UNITED STATES PATENT AND TRADEMARK OFFICE

APPLICATION NO.	FILING DATE	FIRST NAMED INVENTOR	ATTORNEY DOCKET NO.	CONFIRMATION NO.
10/743,940	12/23/2003	Richard C. Caponi	SPIROL/111/US	9382

Office Action Summary	Application No. 10/743,940	Applicant(s) CAPONI, RICHARD C.	
	Examiner Michael P. Ferguson	Art Unit 3679

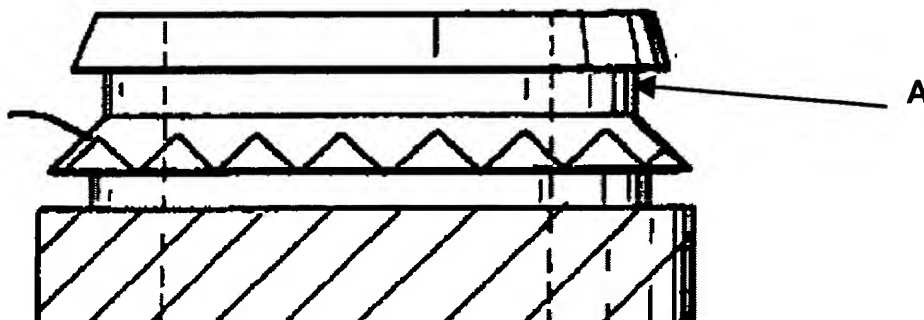
As to claim 24, Dove et al. disclose a pin **10** for insertion in a hole in a host material **22,24** and frictional engagement therein, comprising:

an elongated cylindrical body having a longitudinal axis, a cylindrical pilot portion **16** having a first diameter, and a formed portion **14** defined by a plurality of alternating helical lands **A** and grooves **B**, each the land having a width **C** (Figure 4 reprinted below with annotations) measured perpendicular to the a substantially uniform height longitudinal axis, a majority of each land having extending above the first diameter, the width being at least approximately five times the height,

wherein the lands are oriented at an angle of approximately 45 degrees relative to the longitudinal axis (Figures 1 and 4).

As to claim 27, Dove et al. disclose a pin **10** wherein the width **C** is between five and fifteen times the height.

As to claim 33, Dove et al. disclose a pin **10** wherein the grooves **B** have a width **D** measured perpendicular to the longitudinal axis and the width of the grooves is approximately equal to the width **C** of the lands **A** (Figure 4).
